RED DEER
Deerpark Subdivision
Outline Plan
Showing a
Subdivision
of the
S.W.1/4 SEC.14-38-27-4
for
MELCOR DEVELOPMENTS LTD.

Jan. 7/97
REVISED: NOV. 20, 1996
REVISED: OCT. 29, 1996
REVISED: OCT. 25, 1996

DEER PARK OUTLINE PLAN

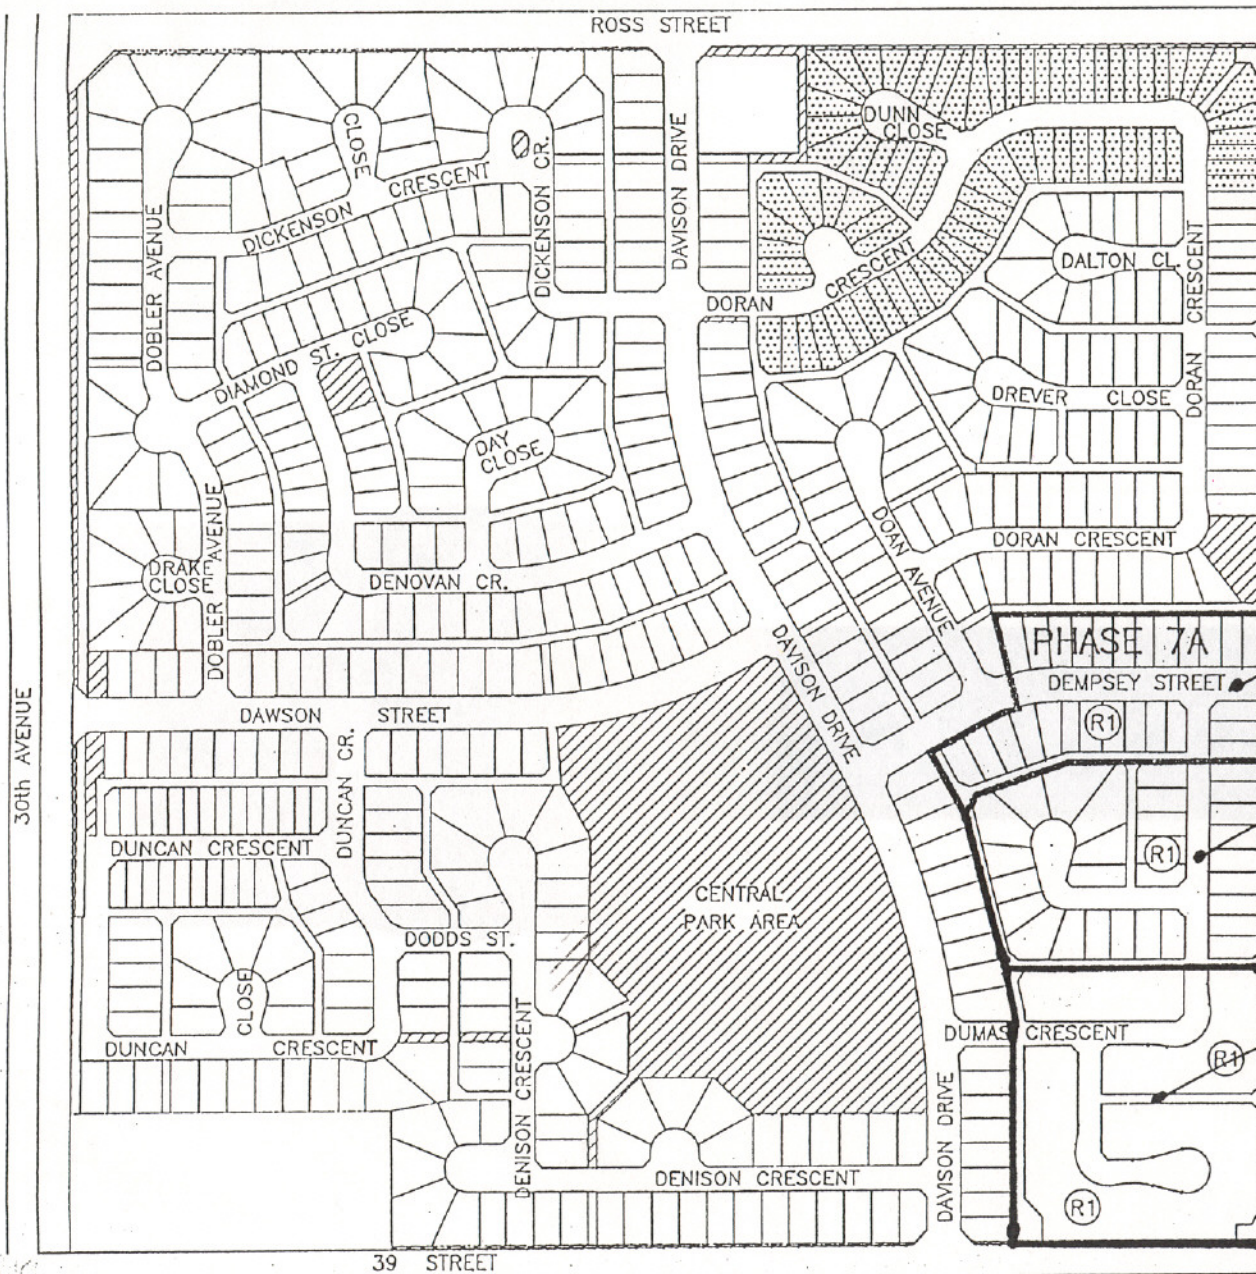
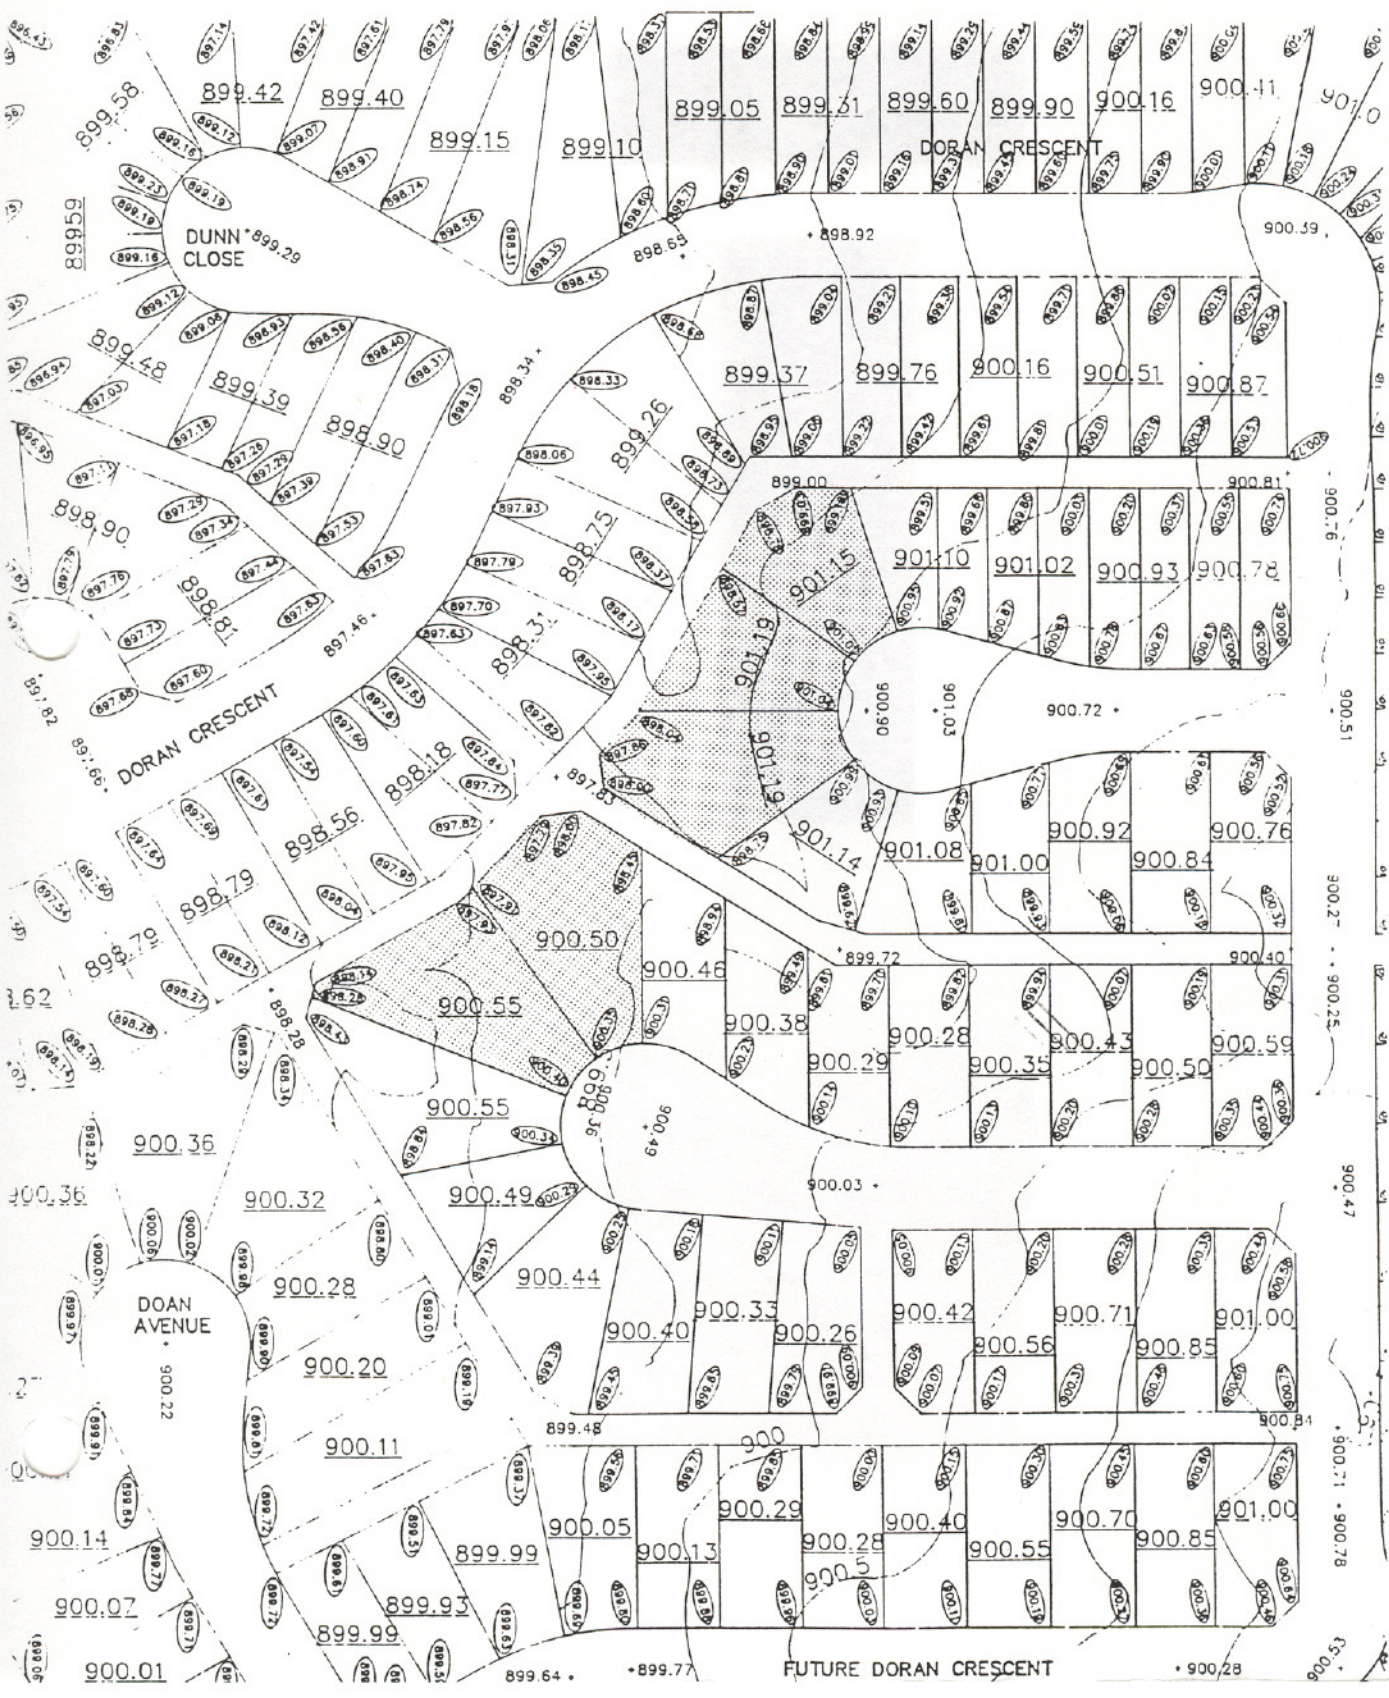
Phase 7A
Increased from 22 to 26 lots

Phase 7B
Increased from 26 to 29 lots

Phase 7C
Minimum Lot Widths of 45 feet
